TENNESSEE VALLEY AUTHORITY
WATTS BAR NUCLEAR PLANT (WBN)
UNIT 1

PROPOSED TECHNICAL SPECIFICATION (TS) CHANGE TS- 98-002
REVISED PAGES

Figure 4.3-2
New Fuel Storage Rack Loading Pattern

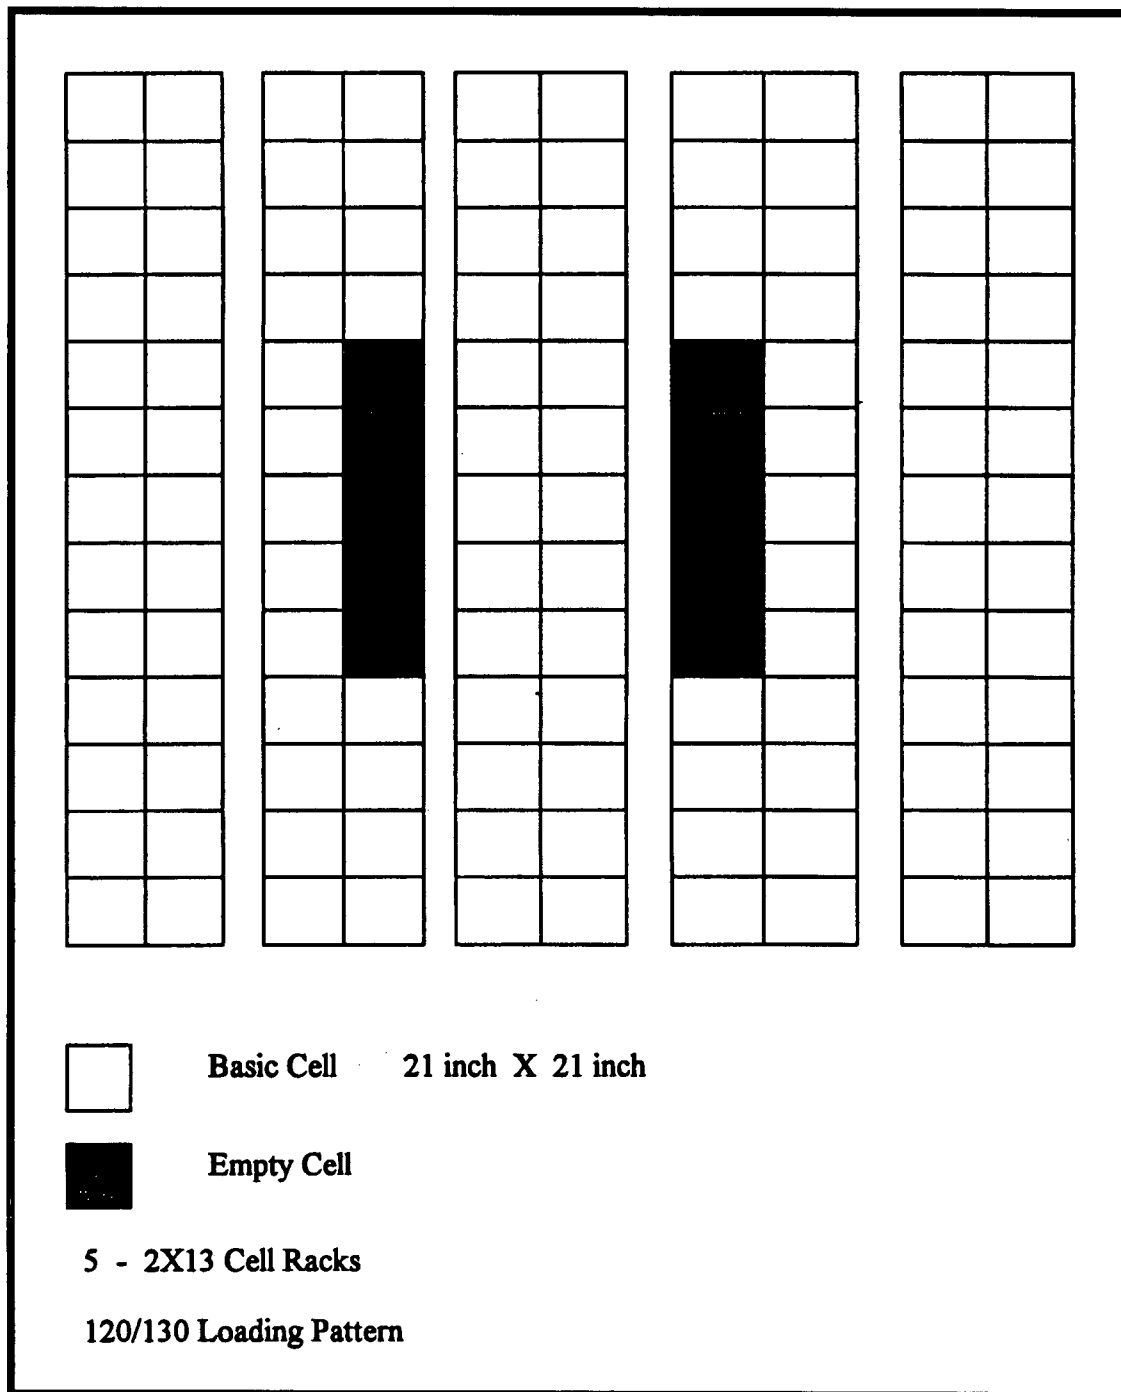
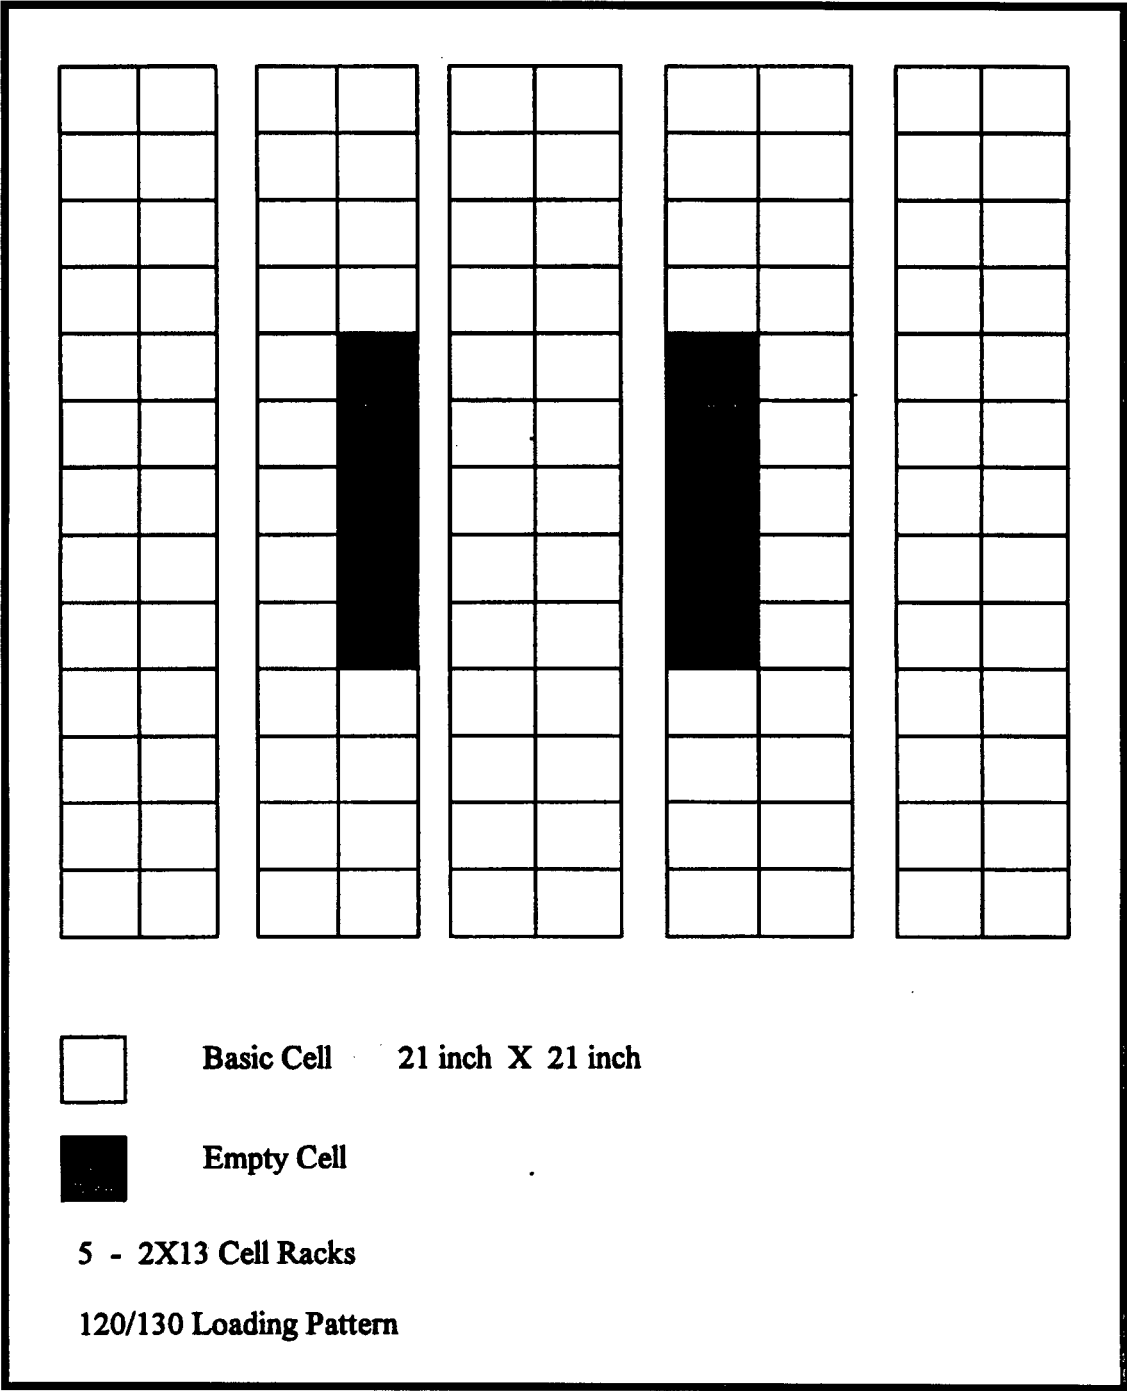
- a. Fuel assemblies having a maximum ~~U-235~~-enrichment of ~~4.3~~ weight percent

U-235 and shall be maintained with the arrangement of 120 storage locations shown in Figure 4.3-2:

ADDED THIS PAGE

- a. Fuel assemblies having a maximum enrichment of 5.0 weight percent U-235 and shall be maintained with the arrangement of 120 storage locations shown in Figure 4.3-2;
- b. $k_{eff} \leq 0.95$ if fully flooded with unborated water, which includes an allowance for uncertainties as described in Section 9.1 of the FSAR;
- c. $k_{eff} \leq 0.98$ if moderated by aqueous foam, which includes an allowance for uncertainties as described in Section 9.1 of the FSAR; and
- d. A nominal 21 inch center to center distance between fuel assemblies placed in the storage racks.
